VEHICLE RECALL

SC306

Subject: Front Steer and Rear Drive Axle Brake Cam Lubrication — CXN and CHN Model Chassis

Figure 2 — Inspect Brake Cam

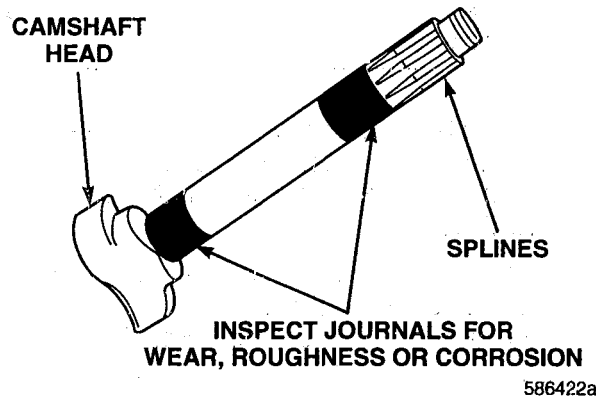
The front steer and rear drive axle brake cams on all affected chassis must be removed and inspected. Inspect the area of the cam journals for wear, roughness or corrosion.

Damaged brake cams and associated brake components must be replaced per the following criteria:

- If there is no wear, roughness or corrosion evident on the brake cam journals, reinstall the cams, but replace the cam bushings and seals and brake shoe retaining hardware with new components.
- If the brake cam journals are worn, rough or corroded, replace the cam, cam bushings, seals and brake shoe retaining hardware.
